## Service Bulletin, 145 BF, Throttle Cable, 1999-03

*Figure 1  
Earlier version*

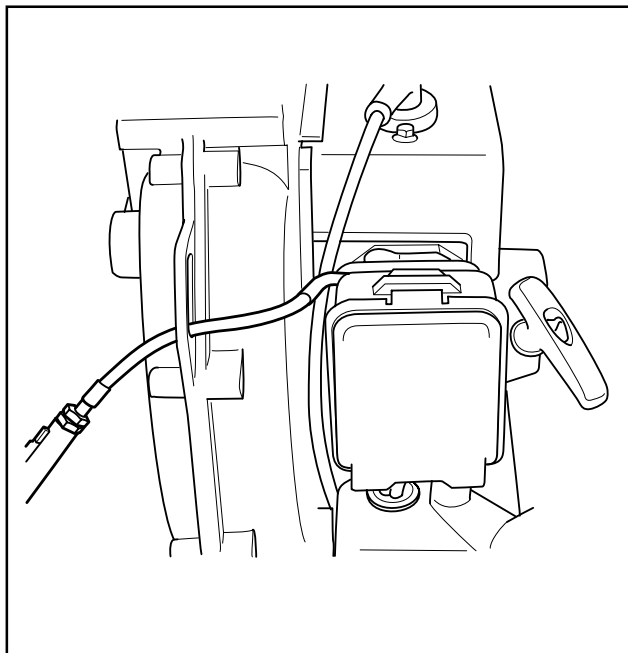
In order to reduce the effort needed to operate the throttle trigger, the throttle cable has been re-routed. See figures 1 and 2. The new arrangement means that the throttle cable is slightly shorter. This change was introduced into production in October 1998.

On the earlier version, figure 1, the cable ran straight out from the side of the carburettor. On the revised version, figure 2, the cable runs straight down from the carburettor.

Earlier machines can also be fitted with the shorter cable if the elbow sleeve nearest the carburettor is turned so that it points straight down. Figure 2.
